Pierre Auger Observatory

Surface Detector Electronics Upgrade

UUB Pre Prototype Production Report

UUB Model version: SDE-002-002-IE00

Figure 29: Vref decoupling capacitors.

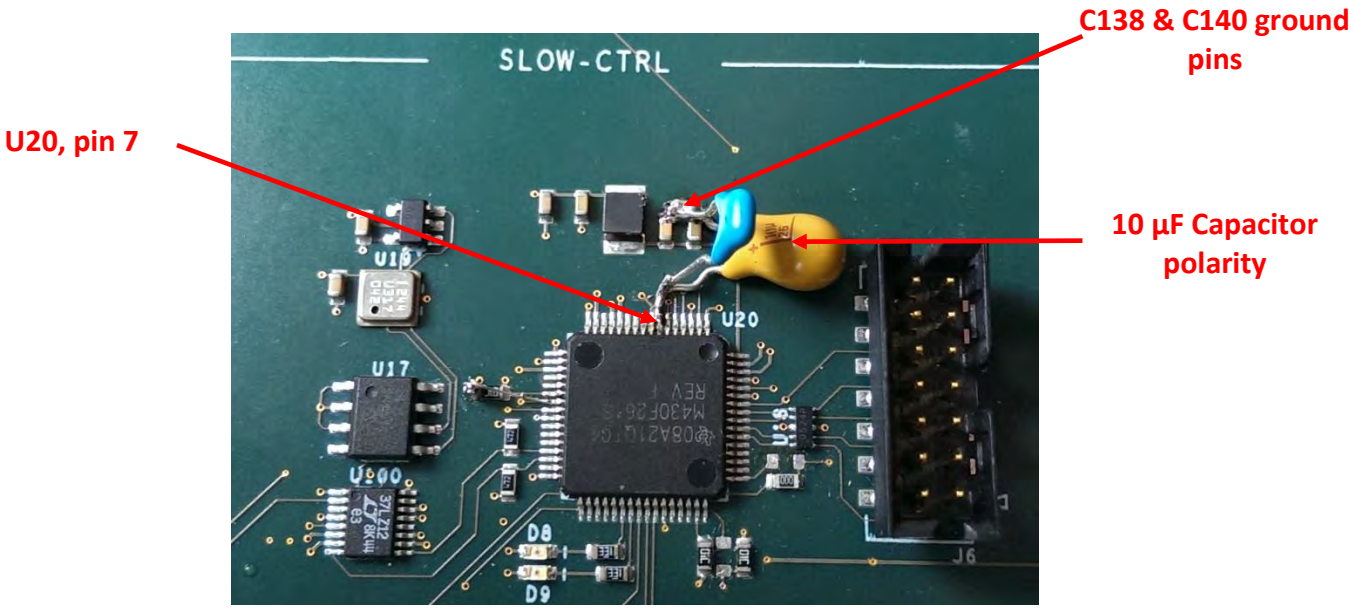
Connect 10 µF 25 Volts and 100nF capacitors in parallel to U20 pin 7 and C138 & C140 ground pins.
Be careful to 10µF polarity connected to U20 pin 7.

- C2_X capacitor: 10 µF 35 Volts trad — ref.: KEMET T350G106K035AT.
- C1_X capacitor: 100 nF 50 Volts trad — ref.: VISHAY K104K15X7RF53L2.

Figure 30: R297_7 pull_up resistor power supply on (Schematic page 12).

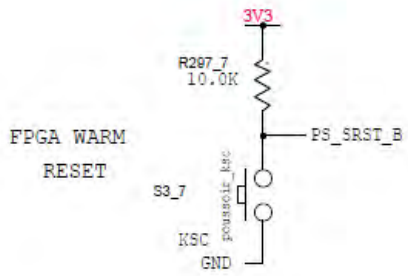
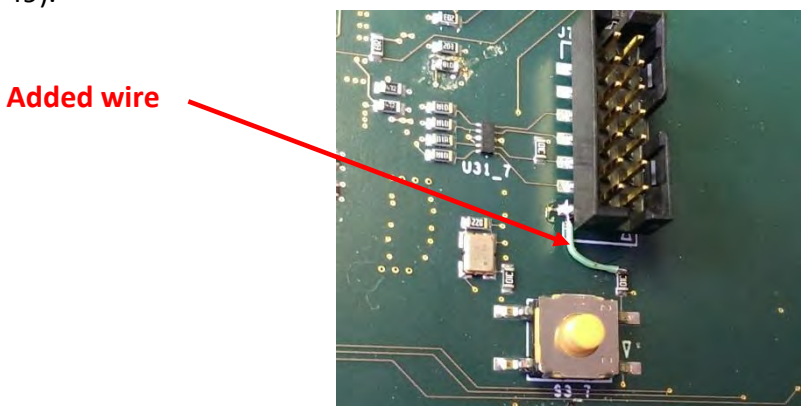
3,3 Volts is missing on Slow-Control Reset Pull-up R297_7 resistor. One pin is unconnected. It must be connected to 3,3 Volts power supply.

A wire must be connected from R297_7 resistor pin to the J7_7 connector pin 2 (3,3 Volts) (NCR n° 2-49).

Figure 32: Pull-up resistor added on watchdog output (Schematic page 12).

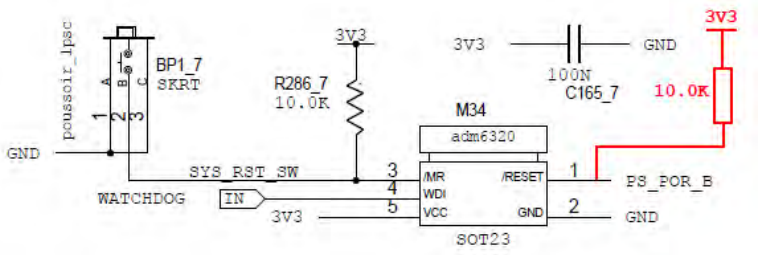
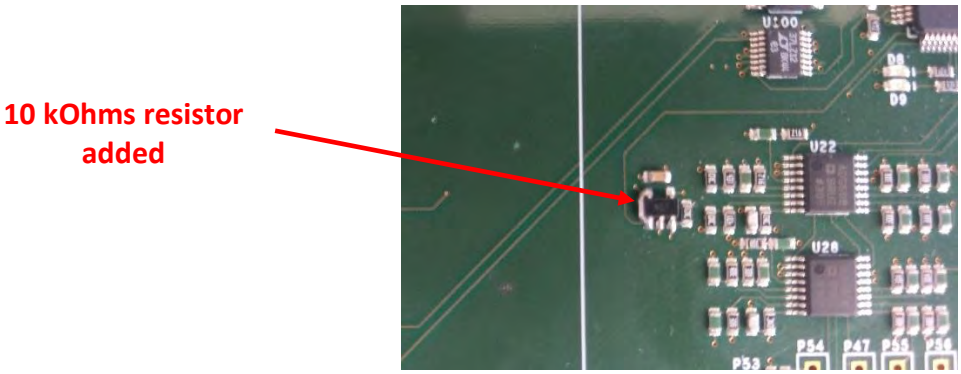
A pull-up resistor is missing in the schematic. A 10 kOhms resistor must be added between 1 and 5 pins for M34 components (NCR n° 2-22).

- R4_X, 10 KOhms 1% 0603 (available in UUB BOM, ref.: RES-017)

Figure 34: SCL & SDA wires must be swapped (Schematic page 7).

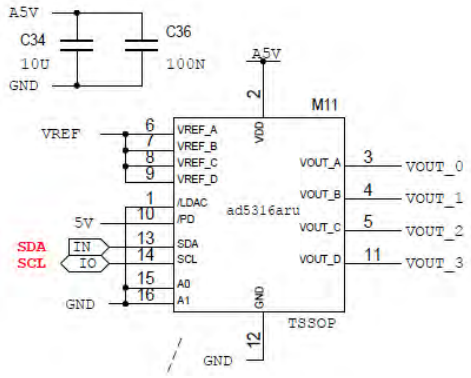
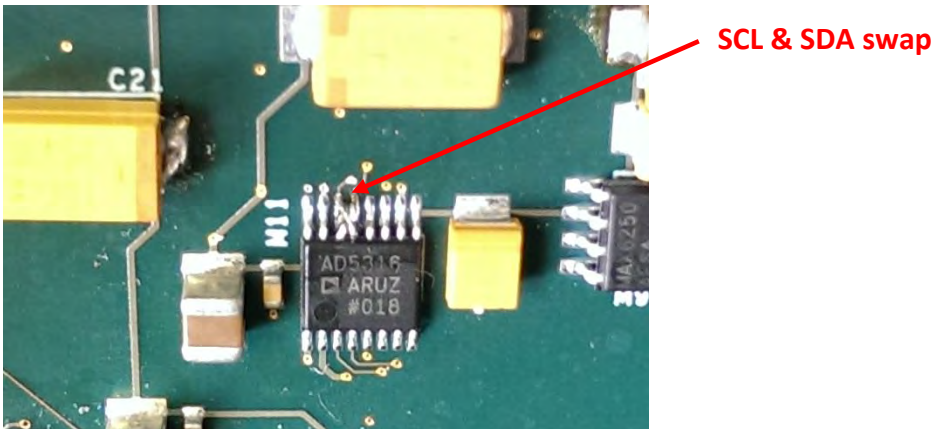
Error in the schematic, SCL & SDA pins must be swapped.

Figure 36: SCL & SDA wires must be swapped on board

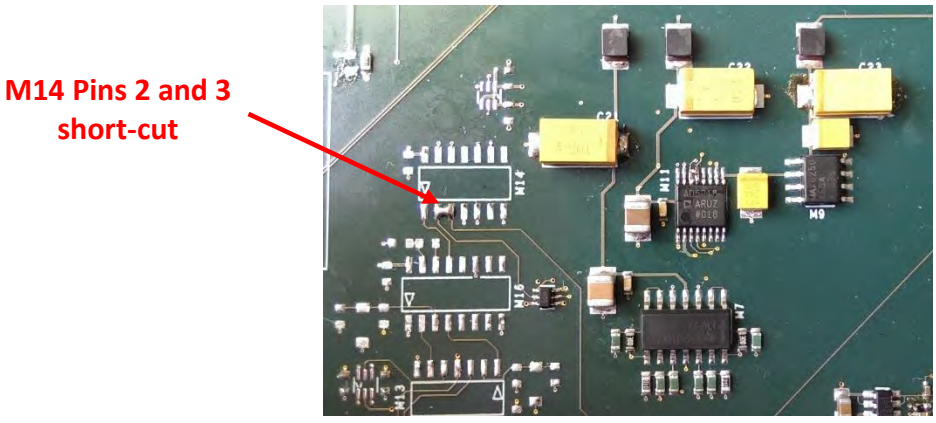
A short-cut must be made between M14 pins 2 and 3.

Figure 37: OFFSET_1 C5_3 decoupling capacitors in wrong place (Schematic page 18).

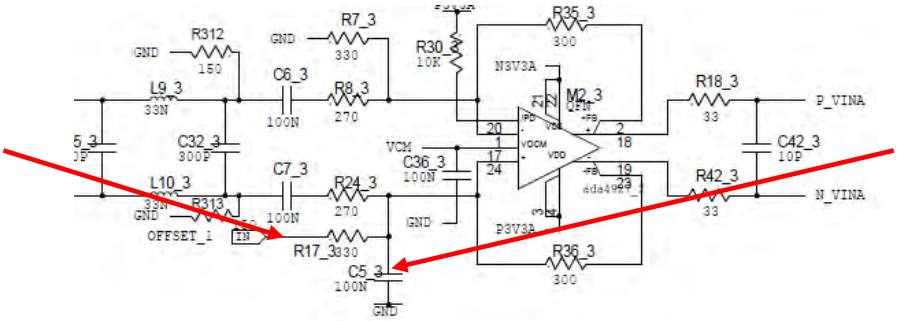
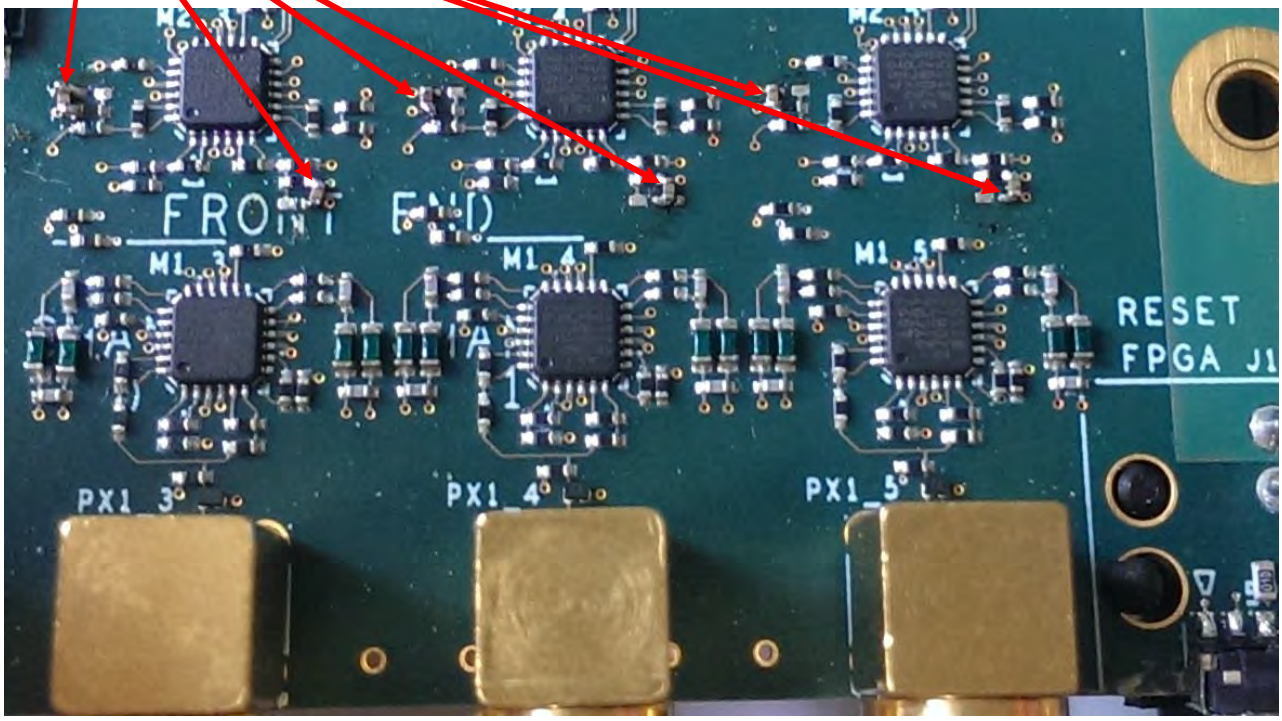
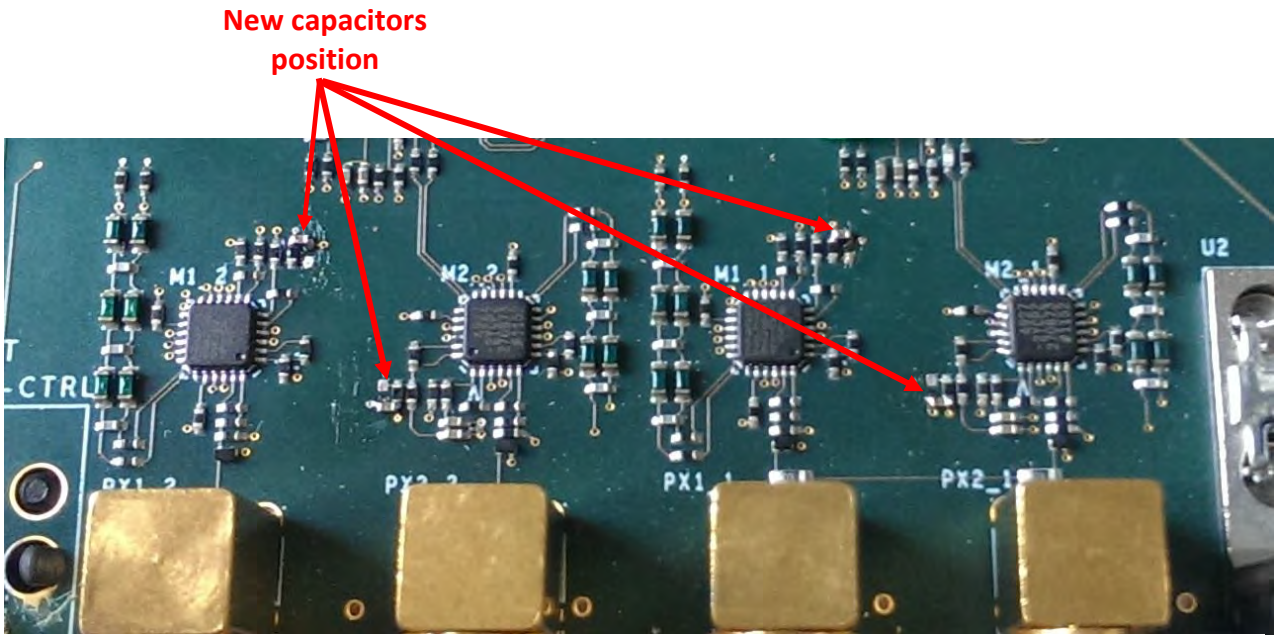
Offset 1 & 2 decoupling capacitors are in the wrong position in the schematic. These capacitors are: C5_1, C8_1, C5_2, C8_2, C5_3, C8_3, C5_4, C8_4, C5_5 & C8_5.

New capacitor position

Bad capacitor position

- C5_1,C8_1,C5_2,C8_2,C5_3,C8_3,C5_4,C8_4,C5_5,C8_5, 100 nF 10V 10% 0402 (available in UUB BOM, ref.: CAP-004)

Figure 40: OFFSET_1 & OFFSET_2 amplifiers decoupling (Schematic page 15).

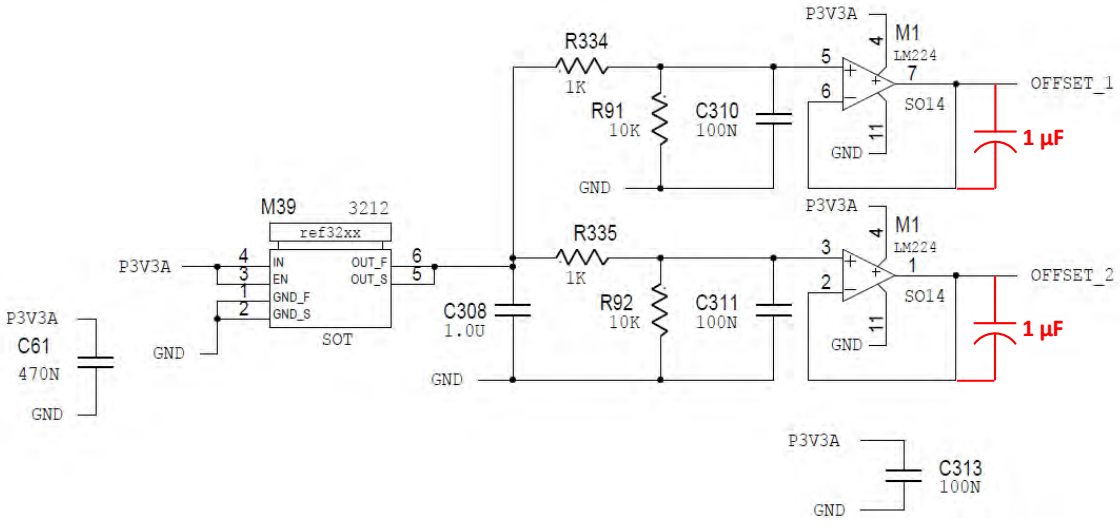
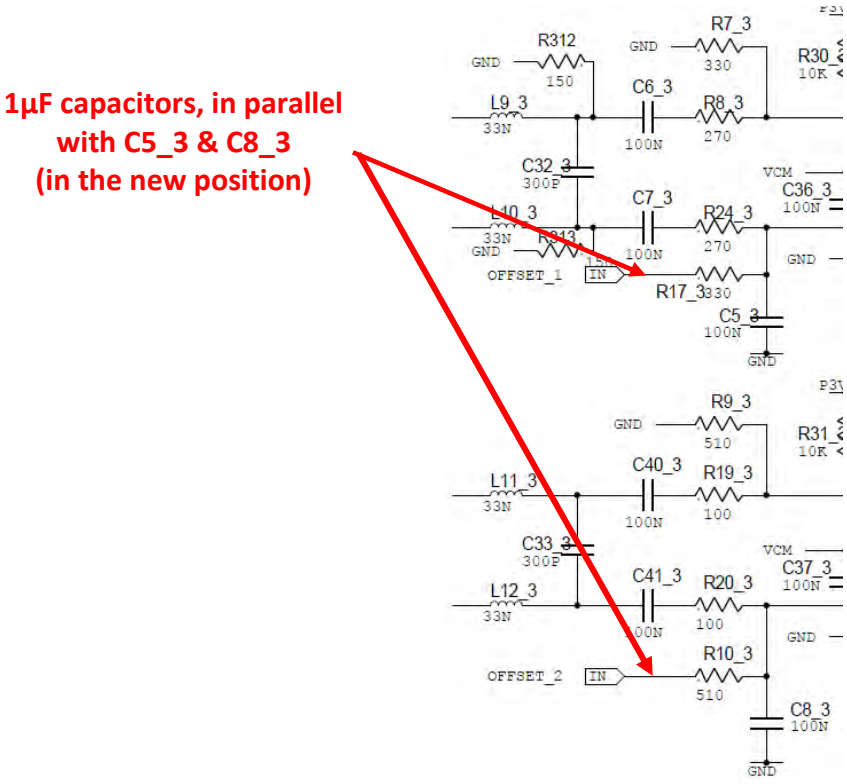
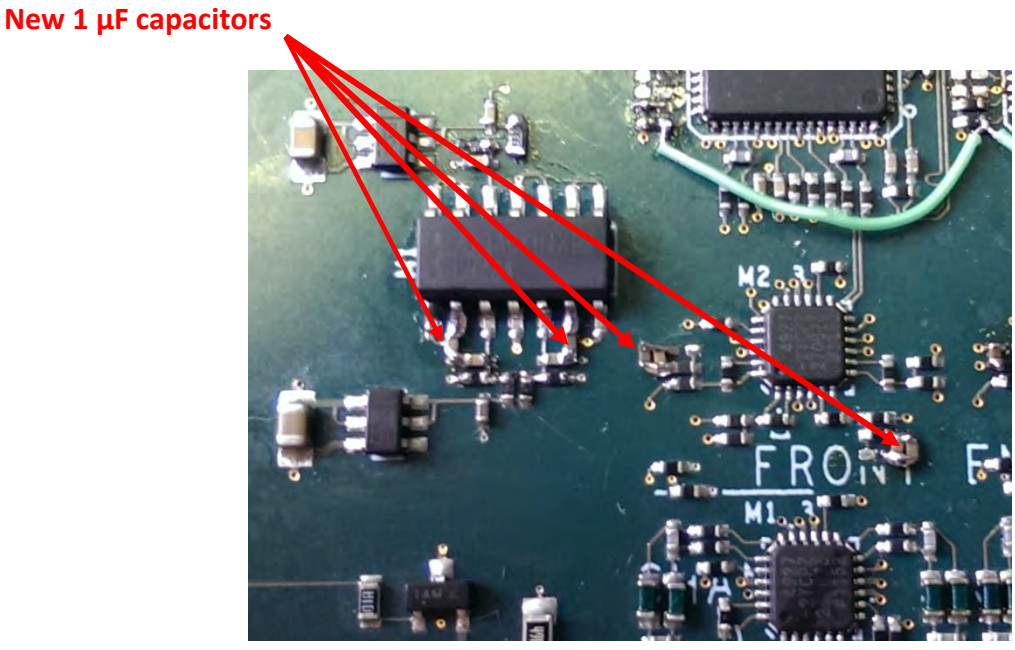
4 Tantalum or ceramic decoupling capacitors must be soldered on board on each OFFSET signal. 2 on amplifier Offset outputs. The 2 others must be close the ADCs.

- C3_X, C4_X, C5_X and C6_X, 1 µF 16 V 0402 (available in UUB BOM, ref.: CAP-012)

Be careful with the capacitor's polarity, it is a Tantalum technology.
Number of operation: 4

Figure 43: Disconnected Vref provided by M1 amplifier (Schematic page 15).

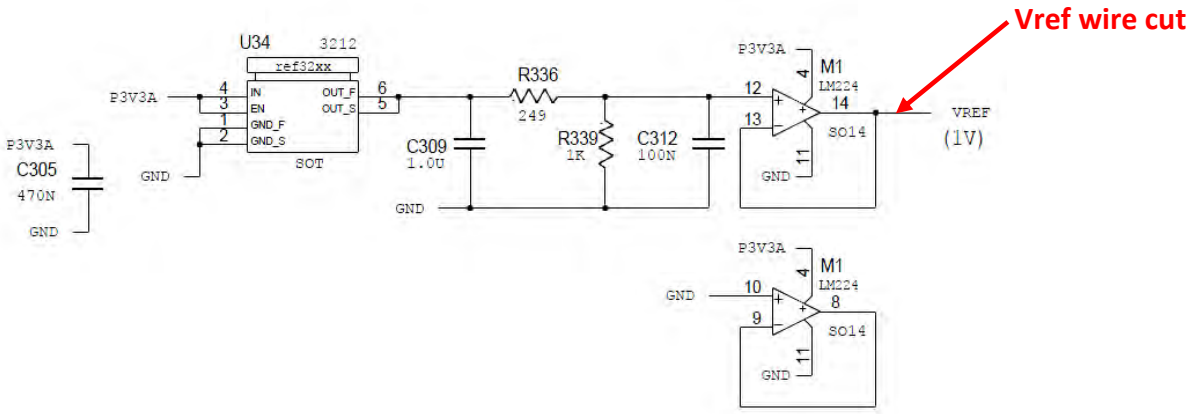
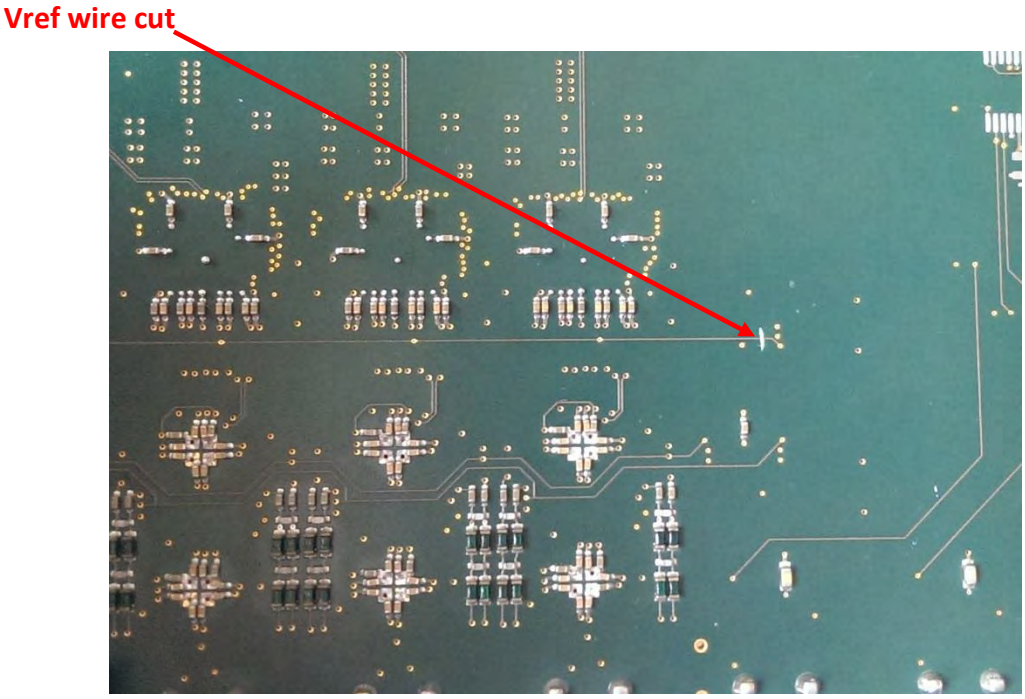
Vref wire provides 1 Volt to all ADCs. A wire cut must be made just after the M1 output pin.

Figure 45: SSD analog input Wire Cut.

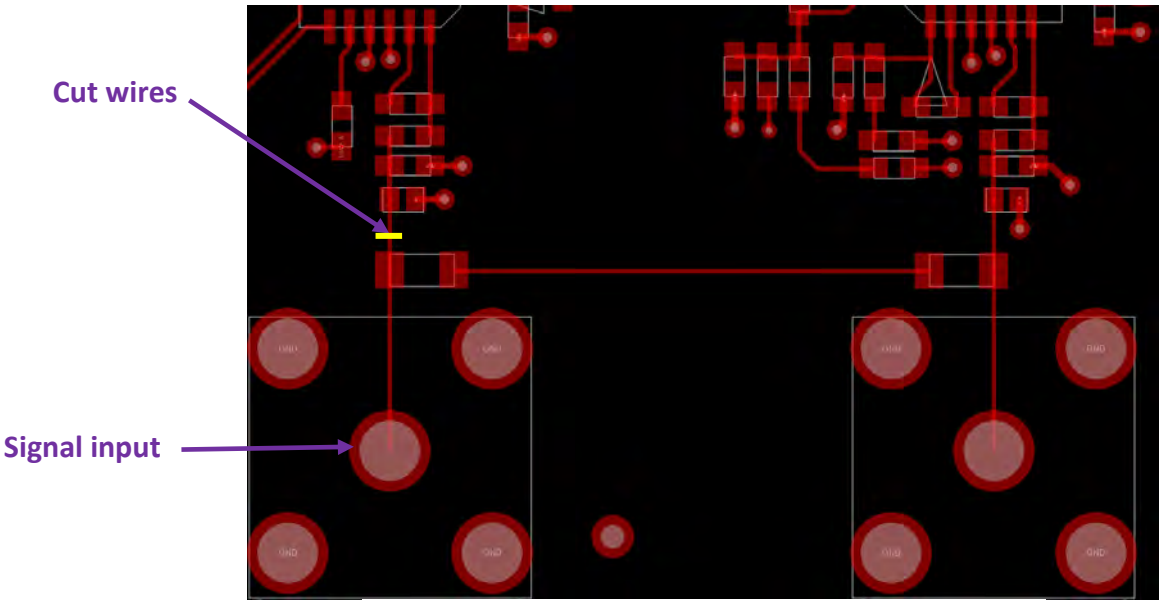
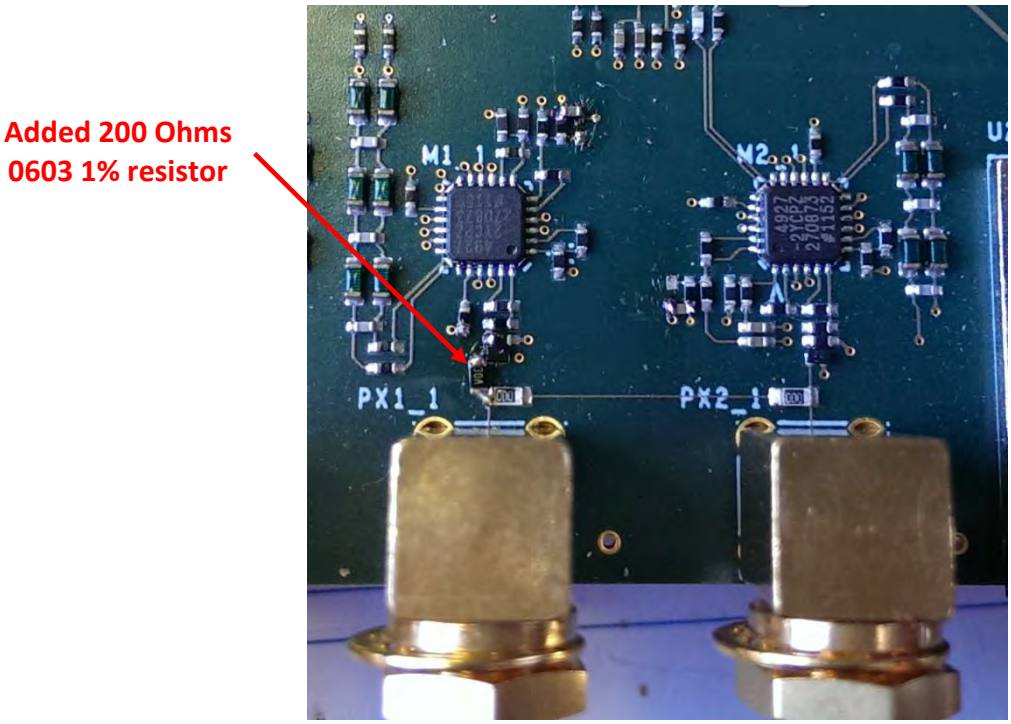
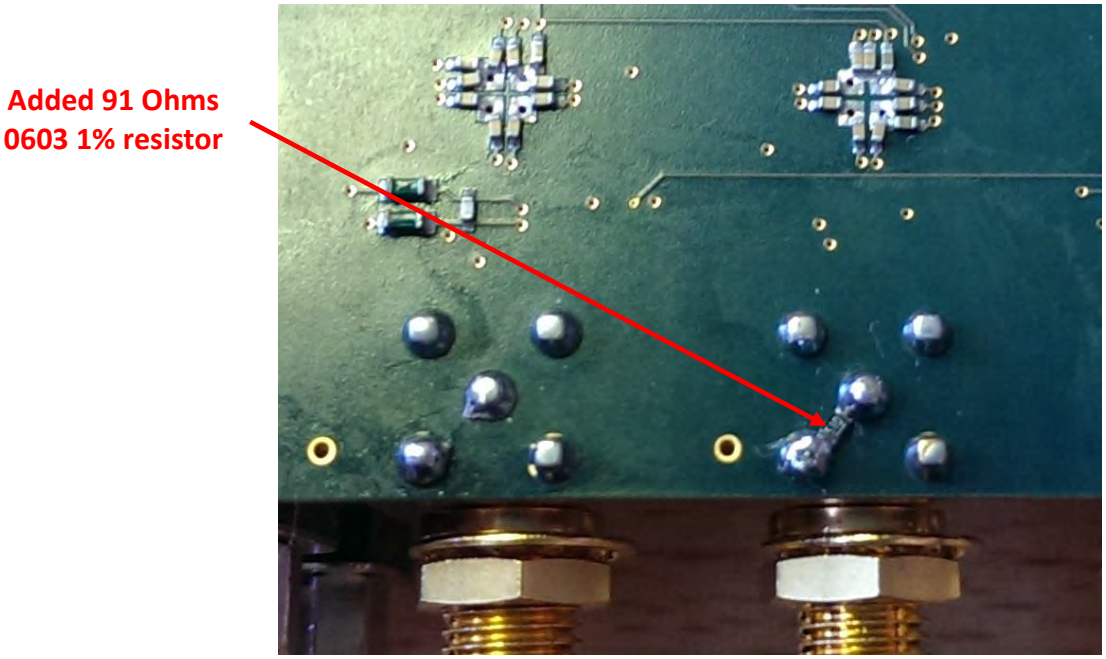
For SSD detector the type 3 front-end design must be implanted with a type1 Bill Of Material. For the impedance adaptation a wire must be cut and a resistor 200 Ohms and 51 Ohms 0603 package added.

- R5_X, 91 Ohms 1% 0603 (available in UUB BOM, ref.: RES-121)
- R6_X, 200 Ohms 1% 0603 (available in UUB BOM, ref.: RES-112)
